# Addendum Report Wahroonga Estate Modification 8

Consideration of change to APZ requirements  
Modification Assessment (MP07\_0166 MOD 8)

October 2020

**Figure 1 |** Extract from Bushfire Assessment Report submitted with SSD 5535. The line indicated in yellow as the 'Zone Boundary' is incorrectly labelled as it is not the E2 zone boundary but the vegetation management transition line (Source: SSD 5535 application documents).

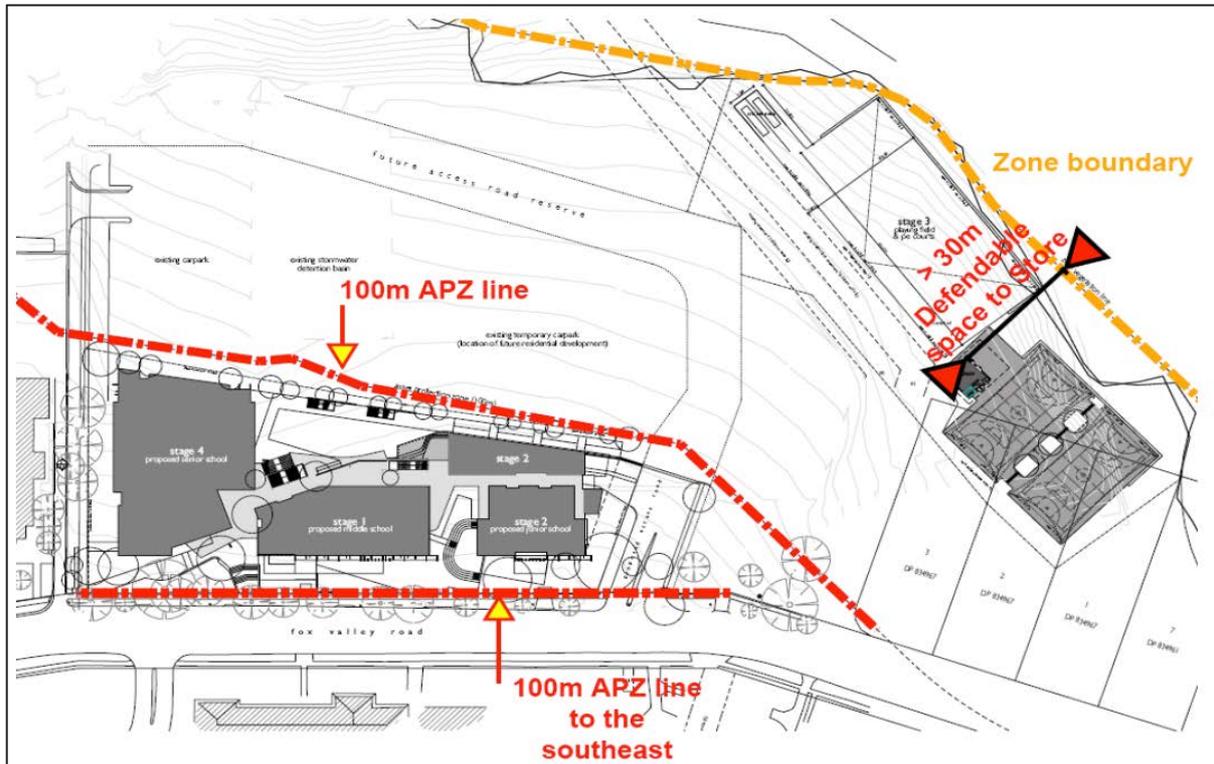
- 2.2.3 However, the APZ line was based on the VMTL and not the E2 zone boundary as required by the approved Concept Plan Drawings and Condition B5. The Application documents did not advise that a different line was being used for the establishment of the APZ and the bushfire assessment report submitted with the application indicates the APZ was based on the E2 zone boundary, advising the school would be “*more than 100 metres from the E2 zone boundary*” and incorrectly showing the Vegetation Management Transition line as the E2 zone boundary in the documentation (**Figure 1**).

- 2.2.4 In approving the plans, the Department was therefore not made aware that a different APZ line was being used in contravention of the Concept Plan approval.

Figure 2 | Revised Scheme (source: Group GSA Architects plan submitted with revised request)

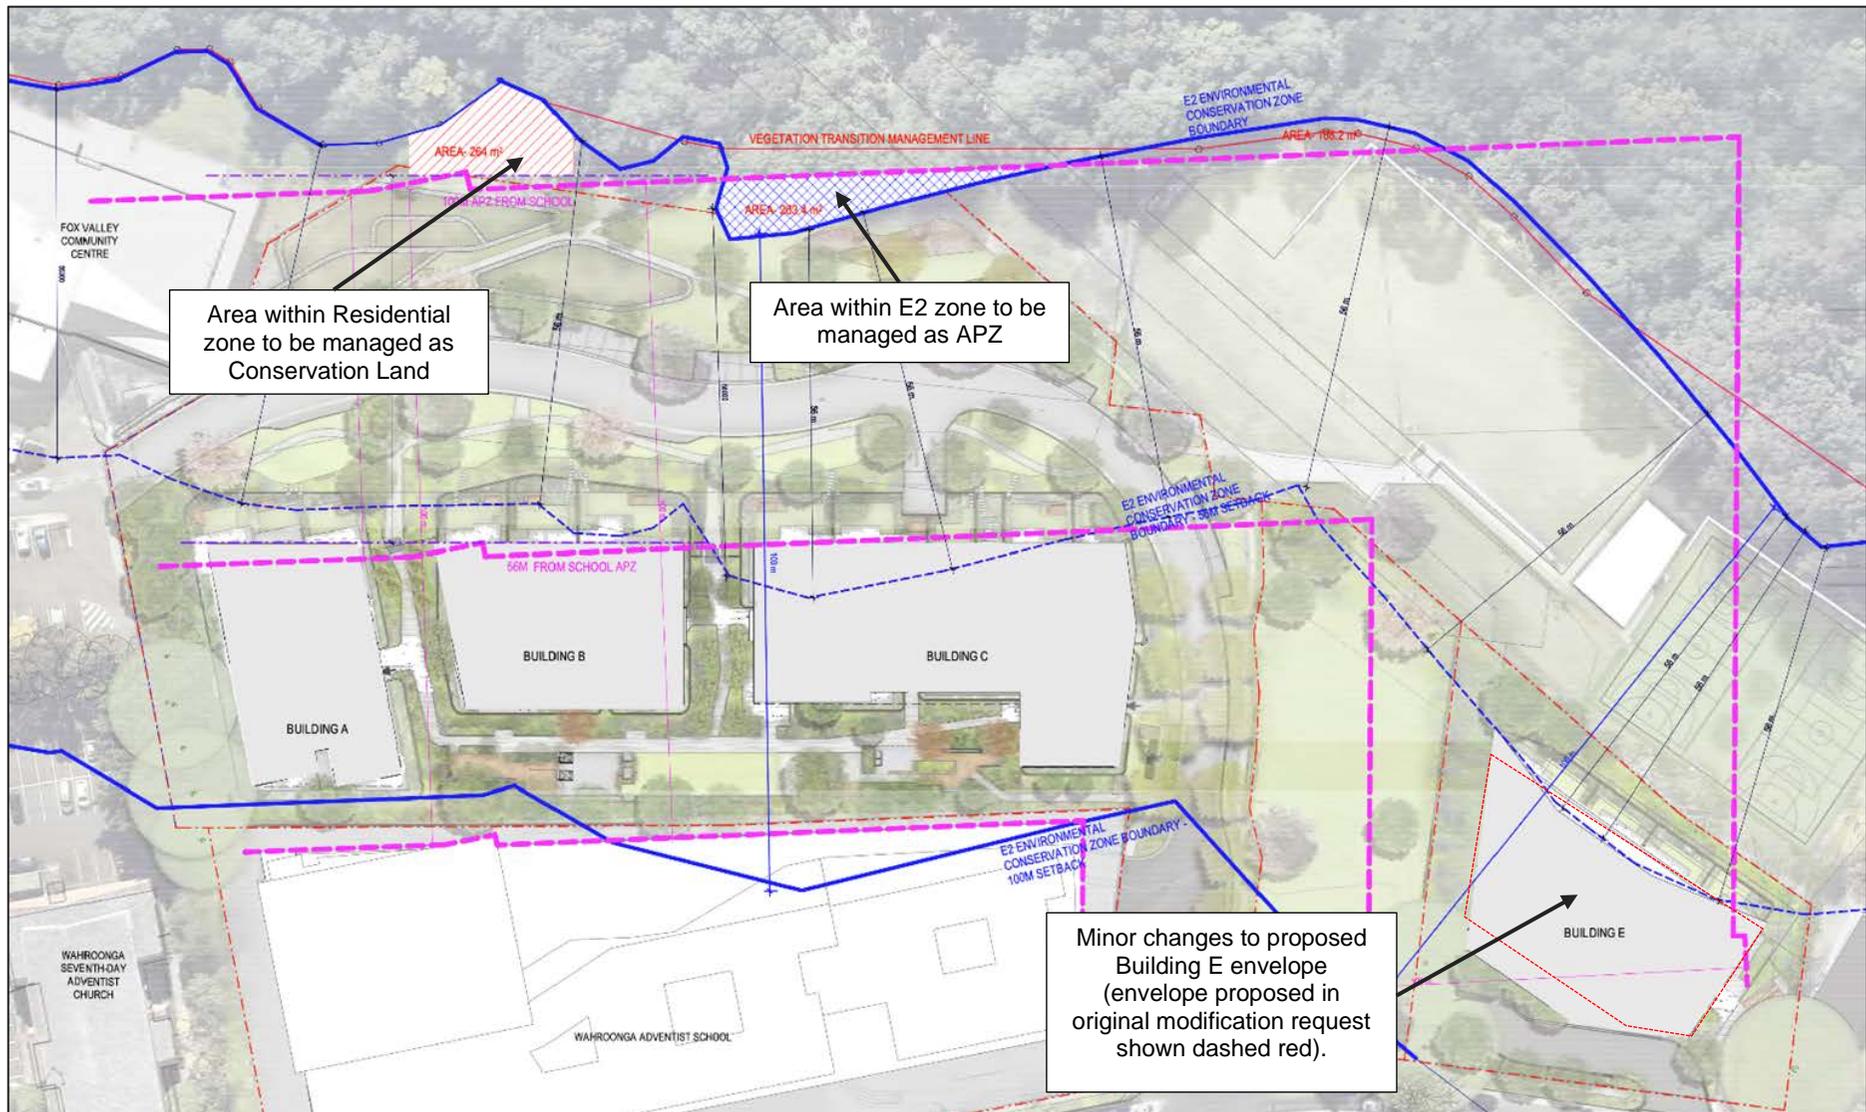
- establishing a new APZ line that would:
  - predominantly follow the E2 zone boundary as required by Condition B5
  - deviate from the E2 zone boundary to the minimum extent necessary to maintain a 100m APZ for the school buildings, creating an area of 263m<sup>2</sup> within the E2 zoned land that would be managed as an APZ (shown blue cross-hatched on **Figure 2**)

- offsetting the 263m<sup>2</sup> E2 zoned land managed as APZ with an area of equal size within the R4 Residential Zone but that adjoins the E2 zoned land and has similar ecological values to the affected E2 zoned land (shown red hatched in **Figure 2**)

- establish a new APZ for the residential buildings of 56m instead of 60m (as permitted by PBP 2019). In conjunction with the change to the APZ line described above, this would allow Buildings A, B and C to be retained as proposed

- modify the proposed Building Envelope for Building E so that it would comply with the requirements of Condition B5 with an APZ that is entirely within the Residential zone (see **Figure 2**)

5.2.8 The approved school requires an APZ of 100m, and the Department acknowledges the fire safety benefits to the existing approved school outweigh the loss of potential biodiversity improvements where an existing APZ is required. However, as shown in **Figure 2**, the required APZ can be achieved without encroaching into the E2 zoned land to the full extent of the VMTL. The Proponent calculates an area of 263.4m<sup>2</sup> E2 zoned land would be required to be managed as APZ to meet the fire safety requirements of PBP 2019 for the school. The Proponent has confirmed this would not require any amendment to the school approval, as the relevant condition on that approval only requires a 100m APZ and does not rely on or refer to the plans which show the larger APZ to the VTML line.

- 5.4.1 The proposed changes include some minor changes to the footprint of Building E to comply with the required APZs (**Figure 2**).
- 5.4.2 The Department notes overall building envelope height would not change and the minimum building setback of 10 metres from Fox Valley Road would be retained. The Department is satisfied that compared to the modification request as previously assessed, the proposed changes are minor and would not alter the Departments previous assessment in relation to this building.

- 5.2.13 The Department therefore recommends the following requirements:
- APZs for the residential buildings not encroach into the E2 zoned land with the exception of the minimum APZ area required for the school

- APZs comply with PBP 2019, allowing the APZs to be reduced from 60m to 56m
  - that prior to approval for Buildings A, B or C on the site (as these would all be affected by the revised amendments), the Biodiversity Management Plan be updated and approved by the Department of Agriculture Water and the Environment to:

- remove all APZs adjacent to the residential flat buildings in Precinct B with the exception of the minimum APZ required for the school
    - adjust the associated VMTL adjacent to the residential flat buildings in Precinct B to be consistent with the E2 zone boundary, but excluding the APZ for the school and including the new offset area to be revegetated
